Chesapeake modifications to Regional Standards Third Edition

**DEEP SANITARY SEWER
SERVICE CONNECTION**

SS_16

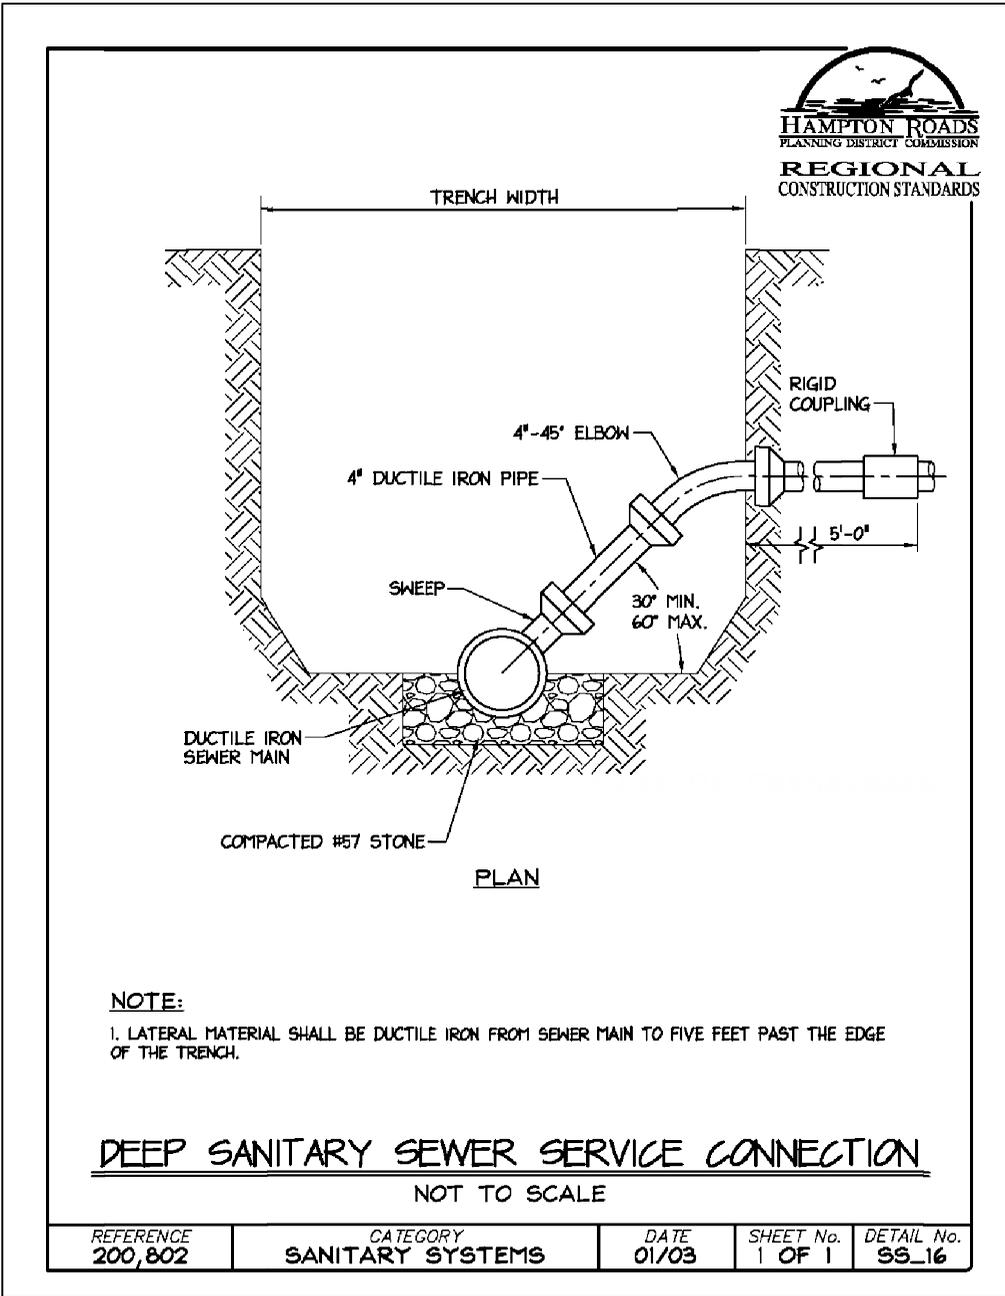
1. Delete references to Ductile Iron Pipe. Lateral material to be the same as the mainline pipe.
2. The remainder of the service lateral shall conform to the requirements of SS-14.
